Project	<b>IEEE 802.16 Broadband Wireless Access Working Group</b> < <a href="http://ieee802.org/16">http://ieee802.org/16</a> >	
Title	<b>Correction of inconsistencies for 802.16-2004 OFDMA symbol clock frequency tolerance</b>	
Date Submitted	<b>2005-03-17</b>	
Source(s)	Juergen Otterbach Joerg Schaepperle Roland Muenzner Torsten Fahldieck Alcatel SEL AG  Uri Perlmutter Shlomo Ovadia Atul Salvekar Roger Eline Intel Corp.	Voice: +49-711-821-32255 Fax: +49-711-821-32453 <a href="mailto:juergen.otterbach@alcatel.de">juergen.otterbach@alcatel.de</a>
Re:	Response to the call for comments IEEE 802.16-2004/Cor1-D1 Corrigendum to IEEE 802.16-2004	
Abstract	Correction of inconsistencies for 802.16-2004 OFDMA	
Purpose	Resolving ambiguity in OFDMA PHY layer §8.4	
Notice	This document has been prepared to assist IEEE 802.16. It is offered as a basis for discussion and is not binding on the contributing individual(s) or organization(s). The material in this document is subject to change in form and content after further study. The contributor(s) reserve(s) the right to add, amend or withdraw material contained herein.

# Correction of inconsistencies for 802.16-2004 OFDMA symbol clock frequenc

Figure 2: Signal-to-interference ratio (SIR) as a function of the absolute tolerance of the sampling clock  $F_s$  in percent of the subcarrier spacing  $\Delta f$

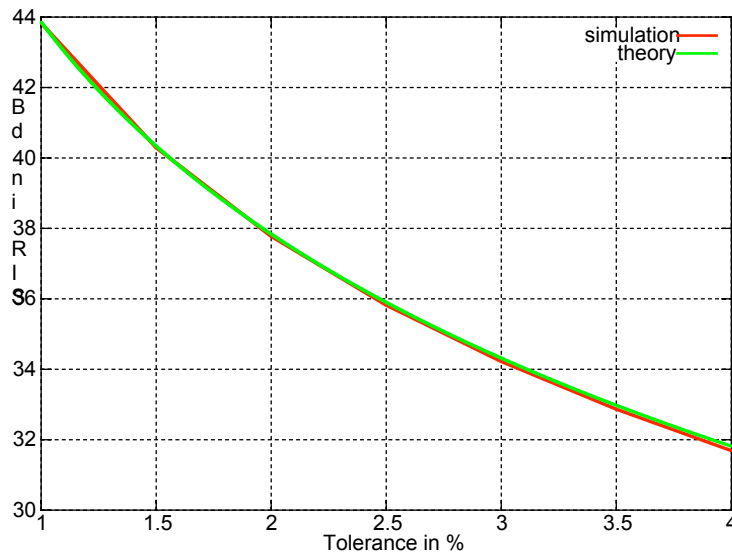
As an indication Figure 2 shows the resulting SIR values in function of the tolerance for the sampling clock frequency for a range of values, that still would leave some margin to the SNR requirement of 24.4 dB for 64 QAM.

A symbol clock frequency tolerance of 2 % of the subcarrier spacing on the other hand, as currently required in 802.16-REVd/D5, results due to the above relation between the symbol clock and the sampling clock frequency in a much higher tolerance for the sampling clock frequency. Therefore this requirement on the symbol clock frequency is not sufficient.

Even though a tolerance of the symbol clock frequency accuracy derived from the range of values for the sampling clock frequency shown in Figure 2 could be sufficient, there is a more direct means to guarantee a still higher accuracy exploiting the requirement that the symbol clock frequency and the center frequency are derived from a single reference at the BS and thus have a fixed and predefined ratio within the system.

~~At the SS, the transmitted center frequency and the symbol clock frequency shall be synchronized to the BS with a tolerance of maximum 2% of the subcarrier spacing~~ At the SS, both the transmitted center frequency and the sampling frequency shall be derived from the same reference oscillator. Thereby the SS uplink transmission shall be locked to the BS, so that its center frequency shall deviate no more than  $\pm 2\%$  of the subcarrier spacing, compared to the BS center frequency.
